**CITY OF BATON ROUGE
PARISH OF EAST BATON ROUGE**

ADDENDUM NO. 1

**SUBJECT: GLASGOW AVENUE SIDEWALKS PROJECT
CITY-PARISH PROJECT NO. 24-EN-HC-0026**

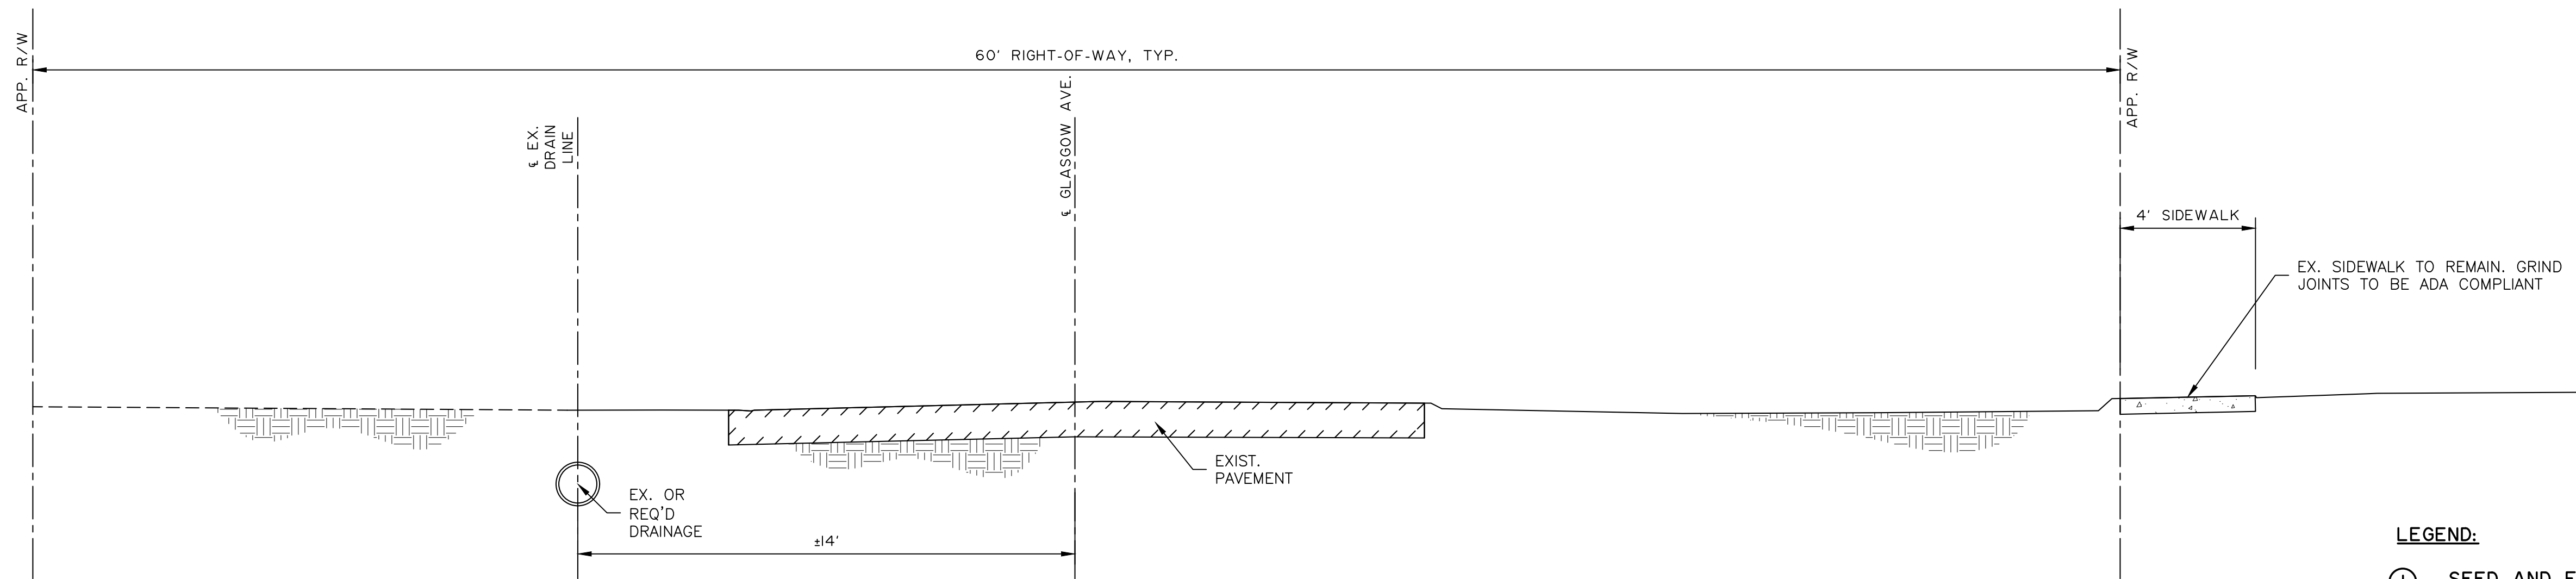
4. Is the 5' Sidewalk shown on sheet 204 for the side weir gate included in that item?
 - ***Response: Sheet 204 should be standard detail 702-40 Weir Inlet, referencing the side weir inlet without the 5' sidewalk. Standard detail 702-41 should be deleted.***

REQUIRED TYPICAL SECTION - @ GLASGOW MIDDLE SCHOOL

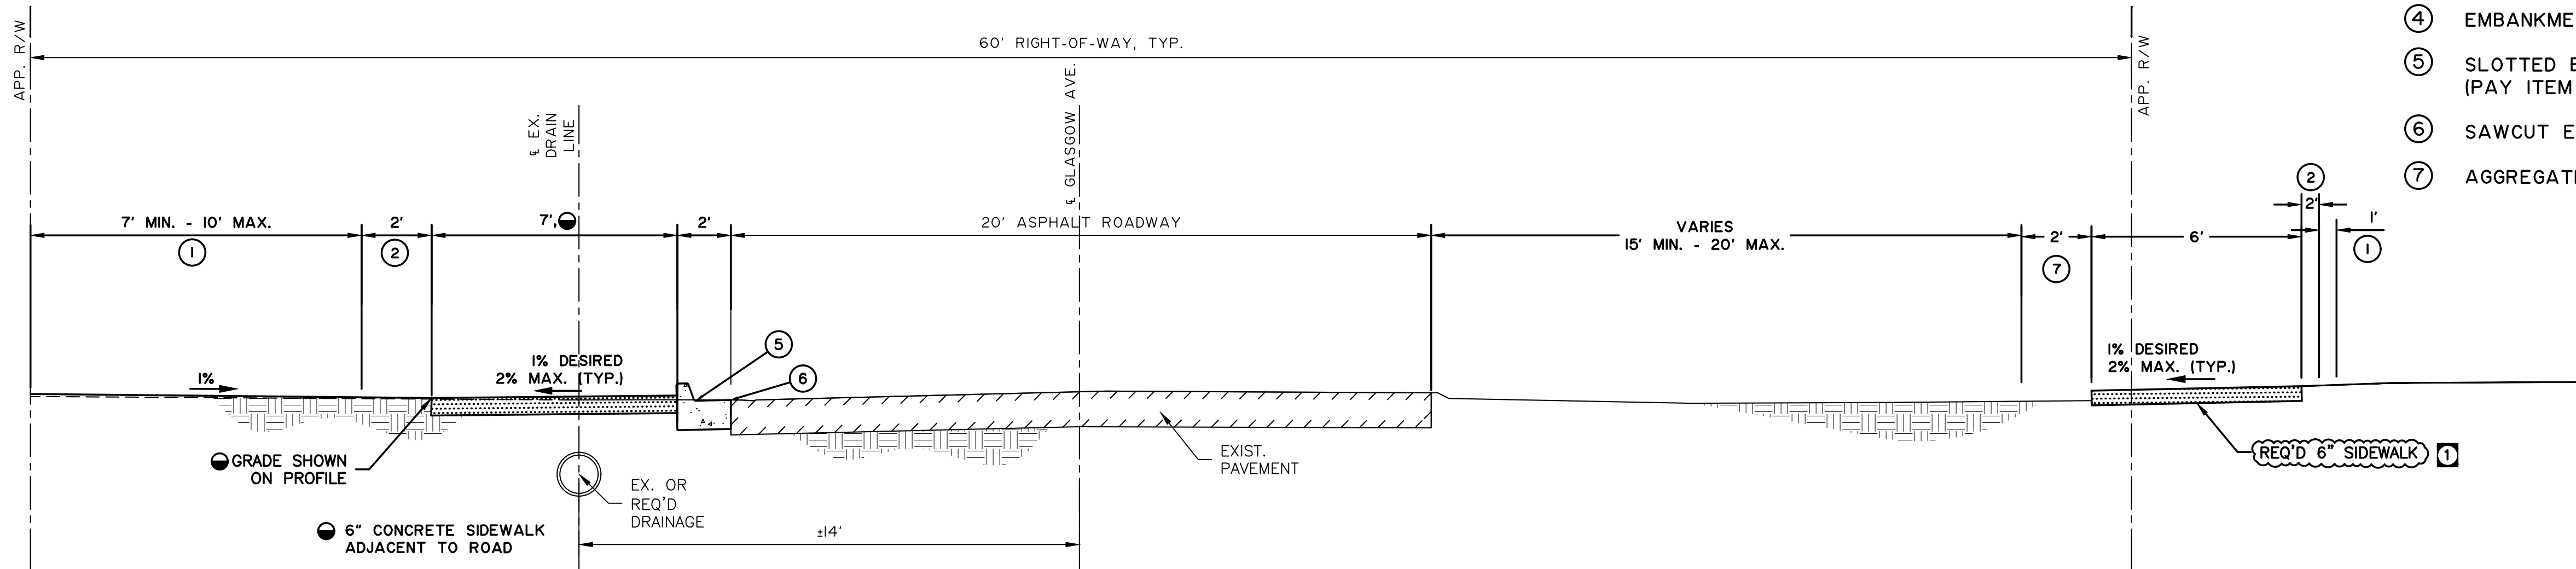
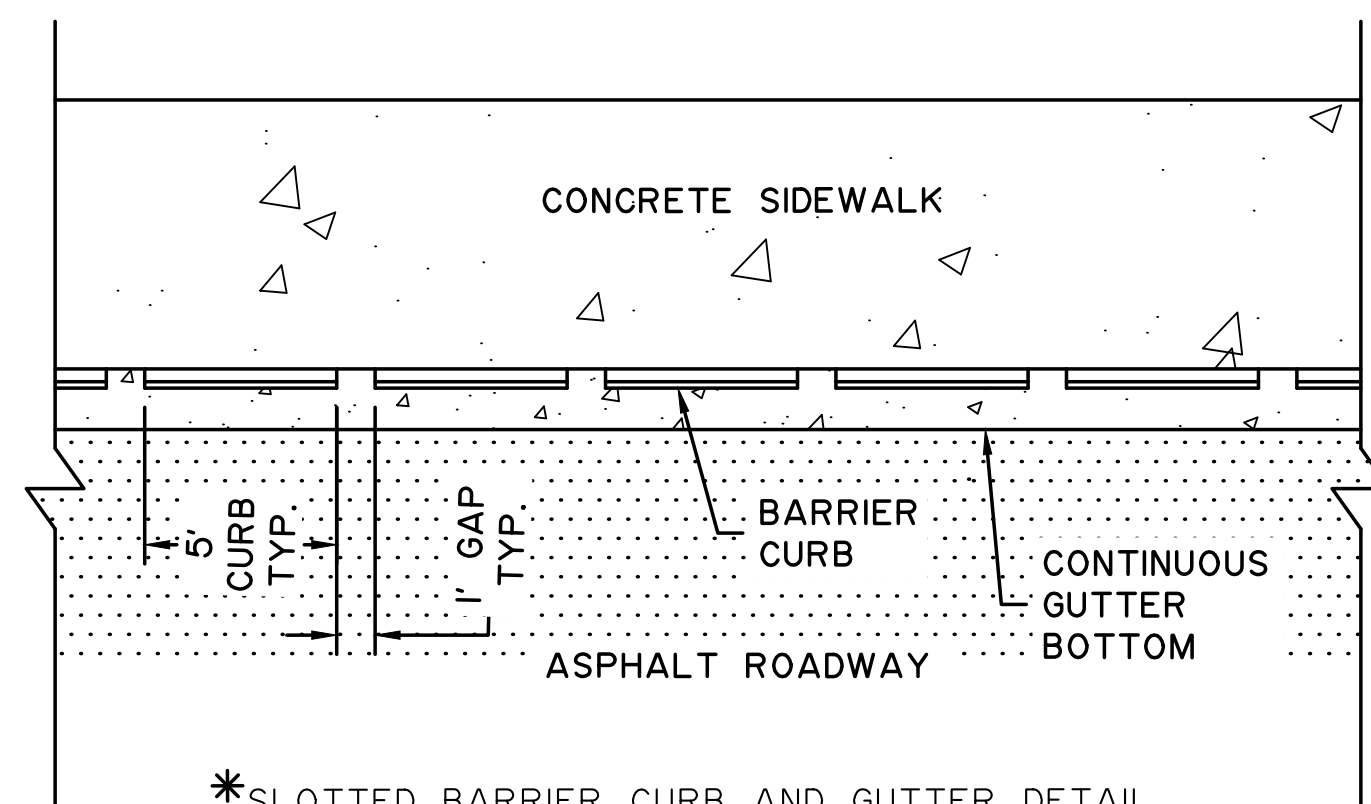
12. On sheet 2 of the drawings, you have a note that says "sidewalk on right side frons ta. 10+90 to sta. 12+70 shall be 6" thick concrete", which seems from 12+70 and on for the right side shall be 4" thick. However, on sheet 4 around station 13+00 you have a note that says "Remove existing sidewalk and replace with 6' sidewalk (6" thick). Is all the sidewalk on the right side of the road 6" thick? If so, that would put it over the 400 square yard quantity, you have in the unit price form. Please advise.

- **Response:** *Per typical section station ranges and notes, sidewalk from Sta. 10+90 to Sta. 12+70 shall be 6" thick, additionally sidewalk from Sta. 12+36 to Sta. 14+24 shall be 6" thick. All other sidewalk is 4" thick.*
